UNITED STATES PATENT AND TRADEMARK OFFICE

APPLICATION NO.	FILING DATE	FIRST NAMED INVENTOR	ATTORNEY DOCKET NO.	CONFIRMATION NO.
10/080,270	02/21/2002	Dorian Thurston True	42576/254485	6974

Office Action Summary

DETAILED ACTION

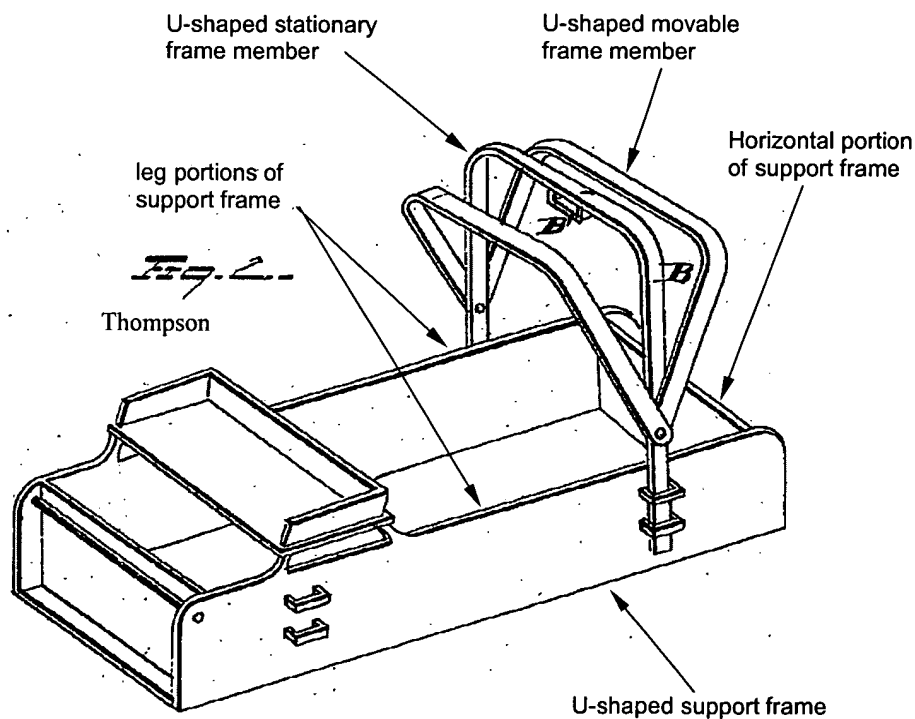
4. Claims 1-4, 6 and 7 are rejected under 35 U.S.C. § 102(b) as being anticipated by Thompson. Thompson discloses an apparatus (Figs. 1-3) for covering a portion of rear compartment of a golf cart, and configured for attachment to a support frame of a golf cart comprising: a stationary member (B) configured for mounting to the support frame member of the golf cart; a movable frame member (Thompson: page 1, col. 2, lines 9-12) configured for mounting to the stationary frame member, and further configured to pivotably rotate over a portion of the rear compartment of the golf cart; and a cover (A) for mounting to the movable frame member rotates over a portion of the rear compartment of the golf cart, the cover covers a portion of the rear compartment of the golf cart; wherein the stationary frame member mounts to a rear portion of the support frame, wherein the stationary frame member connects to a horizontal portion of the support frame; wherein the stationary frame member comprises a U-shaped frame with a horizontal portion and two legs extending relatively perpendicular from the ends of the horizontal portion; wherein the movable frame member comprises a U-shaped frame with a horizontal portion and two legs extending relatively perpendicular from the ends of the horizontal portion; and wherein each leg of the movable frame member mounts to a respective

leg of the stationary frame member (see Figure 2 below). Note: Functional recitation(s) using the words “for” and “configured for” have been given little patentable weight because they fail to add any structural limitations and thereby regarded as intended use language. A recitation of the intended use of the claimed invention must result in a structural difference between the claimed invention and the prior art. If the prior art structure is capable of performing the intended use, then it meets the claim. In re Casey, 370 F.2d 576, 152 USPQ 235 (CCPA 1967) (“The manner or method in which such machine is to be utilized is not germane to the issue of patentability of the machine itself.”); In re Otto, 136 USPQ 458, 459 (CCPA 1963). When interpreting functional language, if the prior art is capable of performing the claimed function—even if not directly disclosed—it anticipates. In re Schreiber, 128 F.3d 1473, 1478, 44 USPQ2d 1429, 1432 (Fed. Cir. 1997). See also MPEP § 2114, 2115.

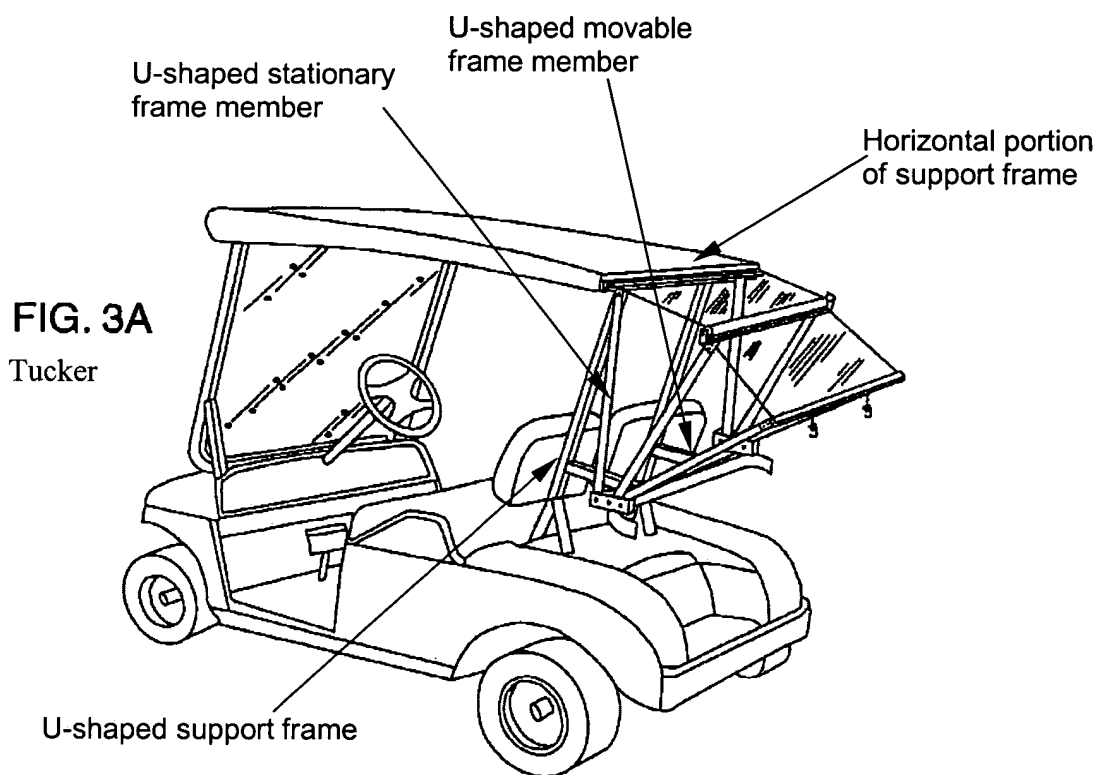
5. Claims 1-7 are rejected under 35 U.S.C. § 102(e) as being anticipated by Tucker. Tucker discloses an apparatus (Figs. 1-3A) for covering a portion of rear compartment of a golf cart, and configured for attachment to a support frame of a golf cart wherein the support frame supports a hard roof top for the golf cart comprising: a stationary member (6, 10, 1) configured for mounting to the support frame member of the golf cart; a movable frame member (9, 19, 3) configured for mounting to the stationary frame member, and further configured to pivotably rotate over a portion of the rear compartment of the golf cart; and a cover (4) for mounting to the movable frame member rotates over a portion of the rear compartment of the golf cart, the cover covers a portion of the rear compartment of the golf cart; wherein the stationary frame member mounts to a rear portion of the support frame, wherein the stationary frame member connects to a horizontal portion of the support frame; wherein the horizontal portion of the stationary frame member mounts to the support frame of the golf cart; wherein the stationary frame member comprises a U-shaped frame with a horizontal portion and two legs extending relatively perpendicular from the ends of the horizontal portion; wherein the movable frame member comprises a U-shaped frame with a horizontal portion and two legs extending relatively perpendicular from the ends of the horizontal portion; and wherein each leg of the movable frame member mounts to a respective leg of the stationary frame member (see Figure below).
